MODIFICATION NOTICE

Contract	Site	Sequence
071	46	0460

Issued by	Drafter	Approval		Date
MET <input checked="" type="checkbox"/> ENG <input type="checkbox"/>	Houle, Denis	<i>Methods</i> Houle, Denis	<i>Quality Assurance</i> Begor, Tricia	2018-01-11
Work Station	Notice Title		Contractor	
23	(TI-3511) raise compressor min pressure valve setting to avoid long term oil leaking		MATTEI TRANSIT ENGINEERING	
Prototype	Tests	FMI - SMI	Replace Notice	
Yes <input type="checkbox"/> No <input checked="" type="checkbox"/>	Yes <input checked="" type="checkbox"/> No <input type="checkbox"/>	520078970 MATTEI TRANSIT ENGINEERING

Field Change Notice

WORK LOCATION

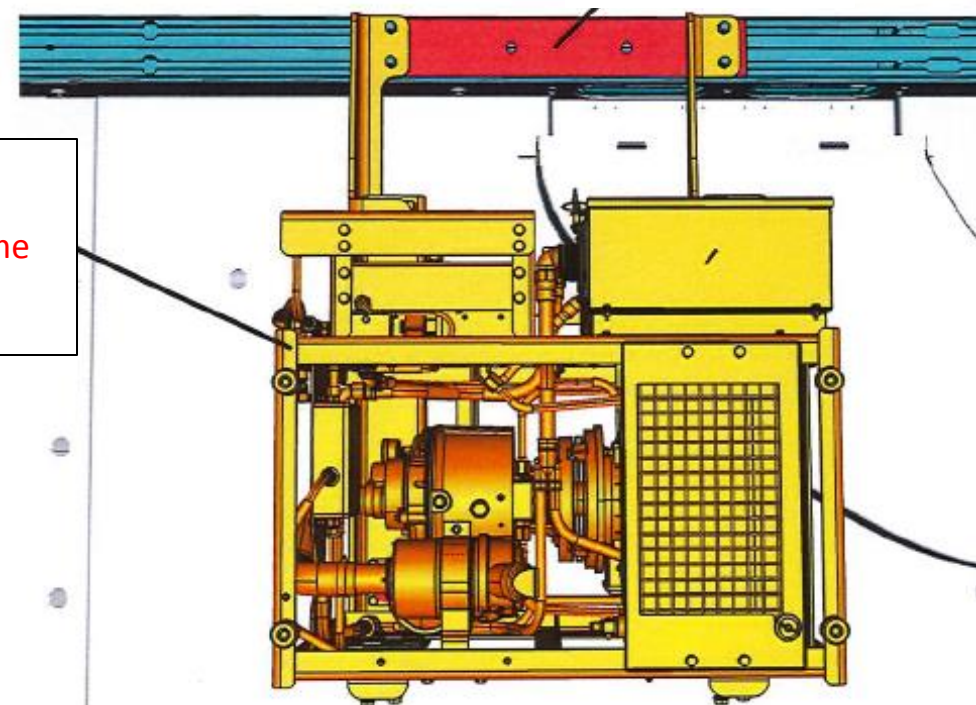
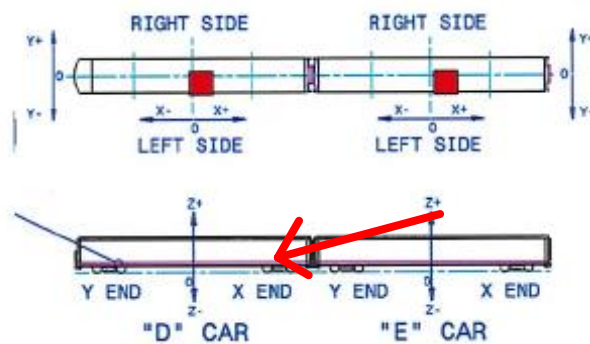
*Locate air supply unit
520078970 on under frame
center left side.

ASSEMBLY STEP 1

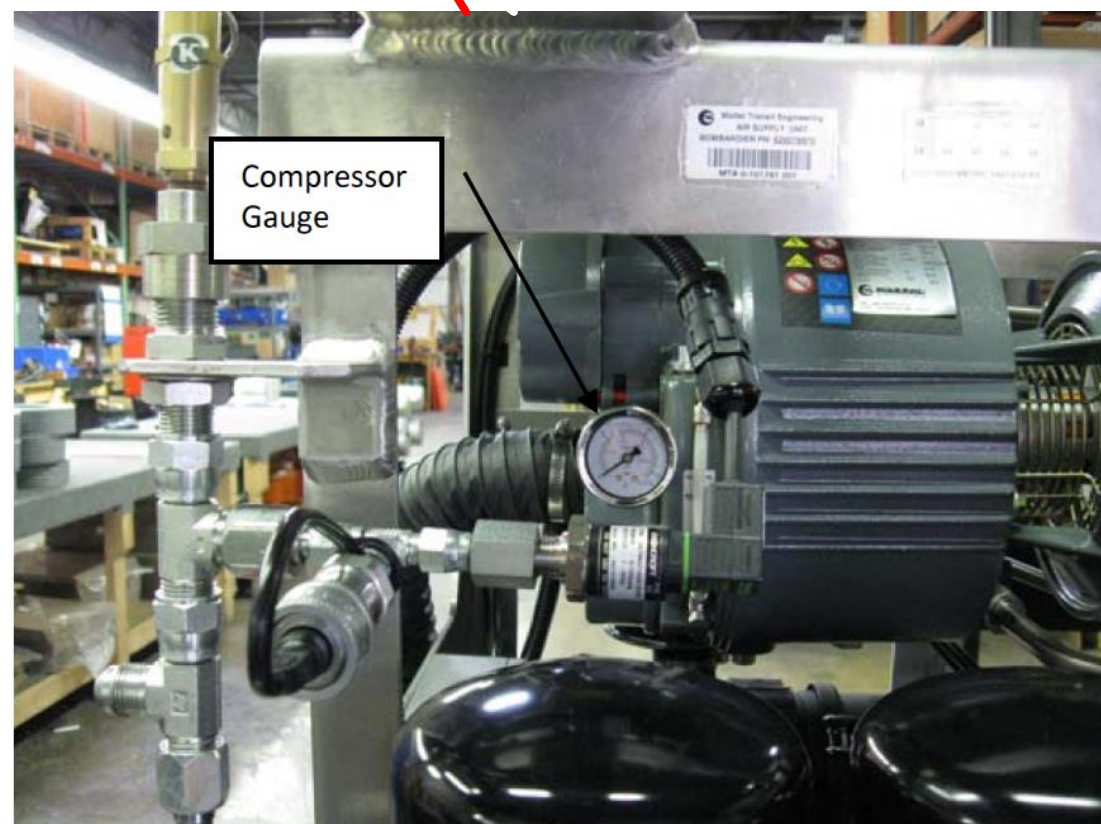
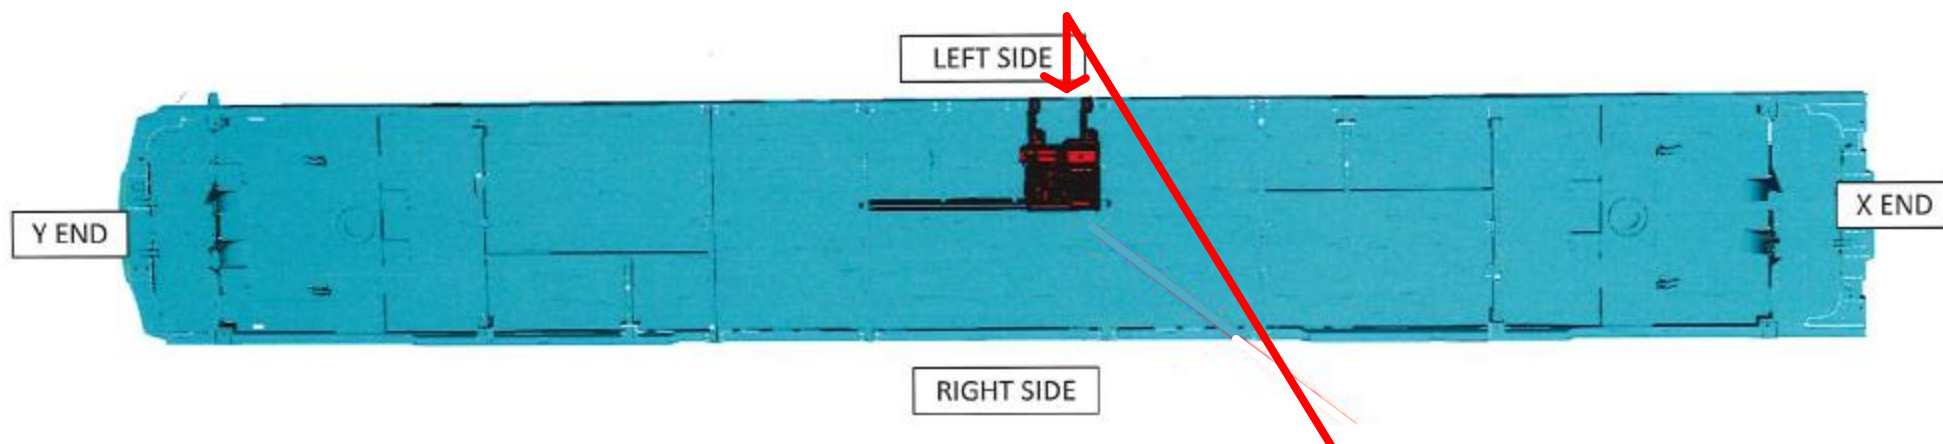
*See Mattie-FCM-17-005 Rev 00. Wear hard hat when working under the car. Turn off the LVDC circuit breaker to prevent the ASU from running. Open the main reservoir (MR) drain valve to reduce MR pressure to 0 psi. Verify compressor gauge says 0 psi before starting this mod.

Figure 1

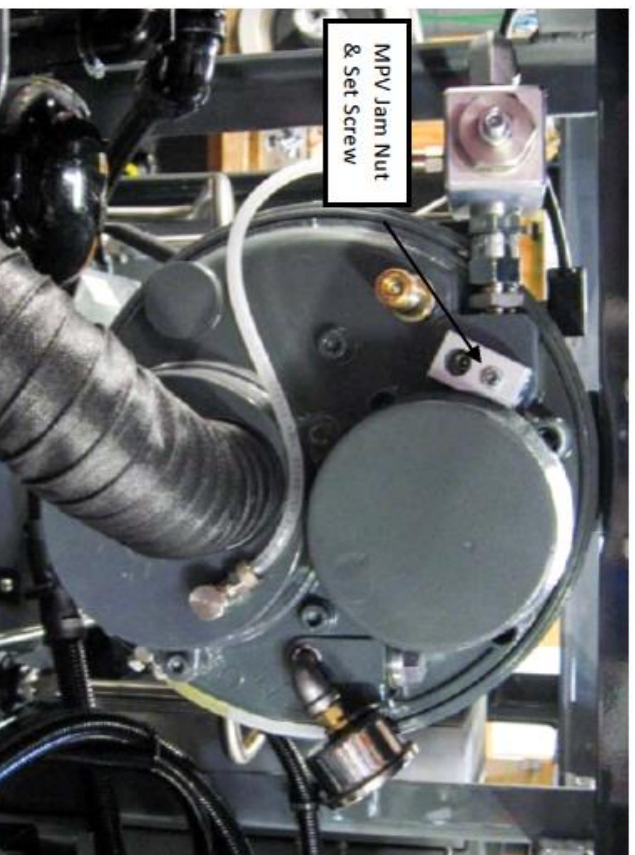
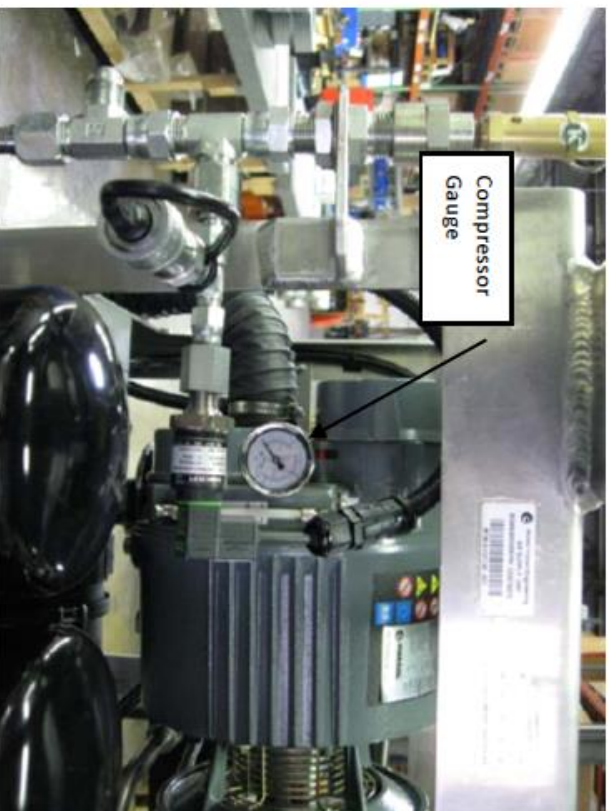
1. Turn OFF the LVDC circuit breaker to prevent the ASU from running.
2. Open the Main Reservoir (MR) Drain Valve to reduce MR pressure to 0 psi.
3. Turn ON the LVDC circuit breaker. The ASU should start.
Note: Air will begin venting from the Drain Valve.
4. Using an 8mm wrench, loosen the Minimum Pressure Valve (MPV) jam nut. See Figure 1.
5. Using a 2.5mm Allen wrench, adjust the MPV set screw until the compressor pressure gauge reads 120 ± 2 psi. See Figure 2.
6. Turn OFF the LVDC circuit breaker to stop the ASU.
7. Wait 30 seconds for the compressor gauge to reduce to 0 psi.

1. Verify the compressor pressure gauge reads 0 psi.
2. Turn ON the LVDC circuit breaker. The ASU should start.
Note: Air will begin venting from the Drain Valve.
3. Verify the compressor pressure gauge increases to 120 ± 2 psi.
4. Repeat pressure adjustment steps, if necessary.
5. Close the MR Drain valve and allow the ASU to run to achieve cutout pressure (approx. 140 psi).

Figure 1

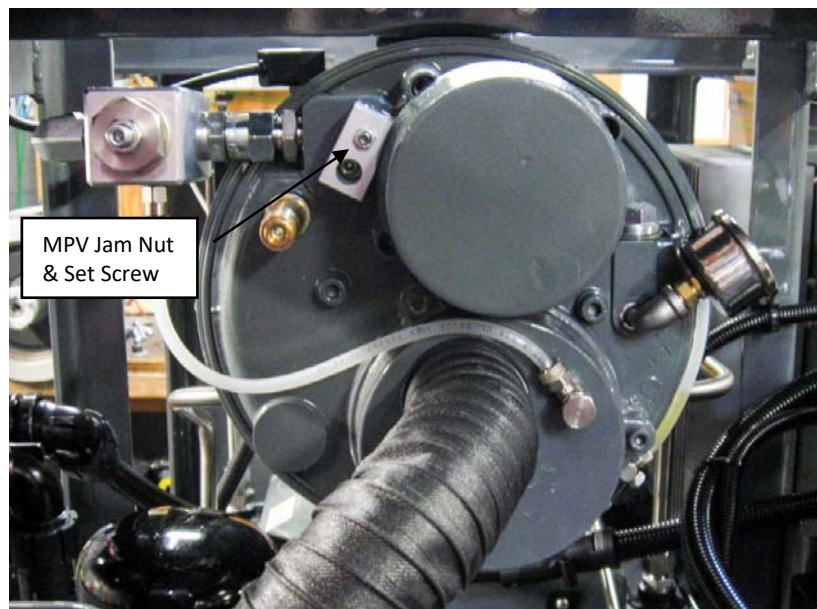
1. Turn OFF the LVDC circuit breaker to prevent the ASU from running.
2. Open the Main Reservoir (MR) Drain Valve to reduce MR pressure to 0 psi.
3. Turn ON the LVDC circuit breaker. The ASU should start.
Note: Air will begin venting from the Drain Valve.
4. Using an 8mm wrench, loosen the Minimum Pressure Valve (MPV) jam nut. See Figure 1.
5. Using a 2.5mm Allen wrench, adjust the MPV set screw until the compressor pressure gauge reads 120 ± 2 psi. See Figure 2.
6. Turn OFF the LVDC circuit breaker to stop the ASU.
7. Wait 30 seconds for the compressor gauge to reduce to 0 psi.
